ADDENDUM NO. 1

Mill Station Park
Brookfield, Massachusetts

February 29, 2012

PREPARED BY:
Fuss and O'Neill, Inc.
317 Iron Horse Way, Suite 204
Providence, RI 02908

SK-1 Sloped Granite Curb

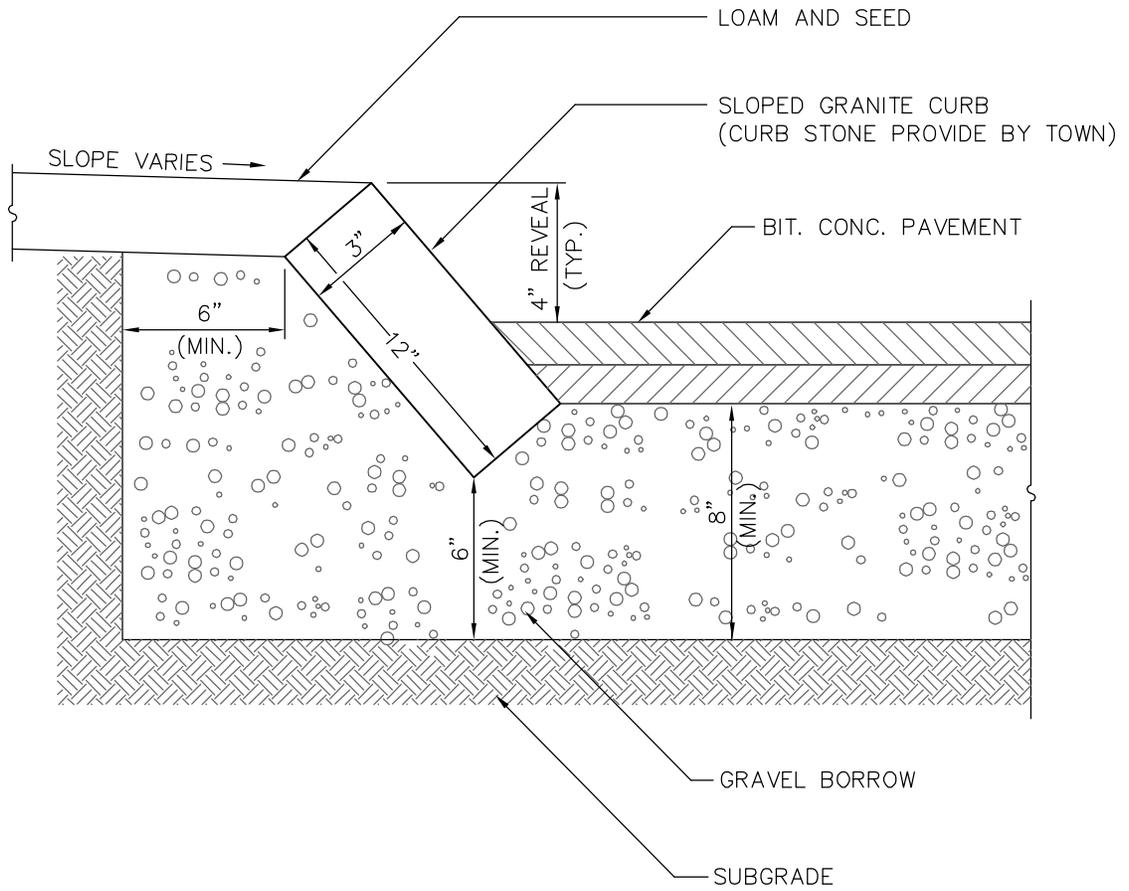
18. *Please clarify what the sloped granite curb is. Is it slope faced granite curb?*

The sloped granite curb is not sloped faced granite curb. A detail depicting the sloped granite curb is provided as Exhibit C of this Addendum No. 1 and shall replace the Sloped Faced Granite Curb detail provided in the Contract Documents.
